AMERICAN SUZUKI MOTOR CORPORATION

Subject: Recall No. 07V-315

Section Title: Restraint
 TSB No. TS 04 08177R

SUBJECT: SAFETY RECALL CAMPAIGN “KY” FRONT SEAT BELT BUCKLE ASSEMBLY REPLACEMENT

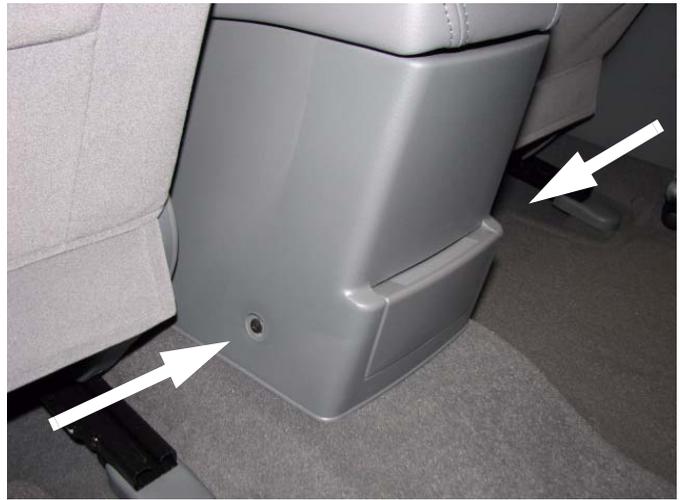
Certain vehicles produced before December, 2005 have buckles with a smaller mounting hole which use the bolt and a steel lock washer shown in figure 1. That bolt and steel lock washer **MUST NOT** be re-used for the new buckle installation.

The **CORRECT** hardware shown in figure 2 must be used.

figure 1

Before December, 2005

figure 2

After December, 2005

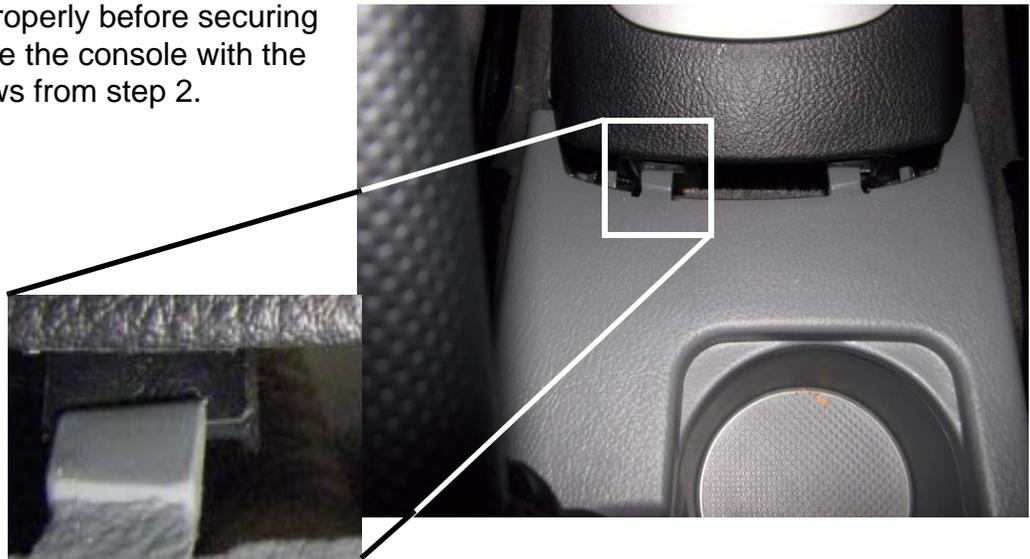
6. Use a 17 mm socket with the appropriate length extension to remove the bolt. The bolt and washer(s) will be re-used.
7. Remove the buckle and install the new buckle with the bolt and washers shown below. **Do not re-use bolt and steel lock washer on vehicles produced prior to December, 2005.** Torque the bolt to 42 Nm (31 lb-ft).

8. Route the buckle switch wire along the same route of the original wire. Allow a small amount of slack in the wire to allow the belt buckle to move for and aft.
9. Wrap the belt switch wire around the adjuster shaft the same as before it was removed. Position the airbag harness and the switch harness to allow plenty of slack for the seat to move all the way forward and aft without putting any tension on the harness. Then wire tie both harnesses into position.
10. Re-connect the buckle switch connector.
re-use
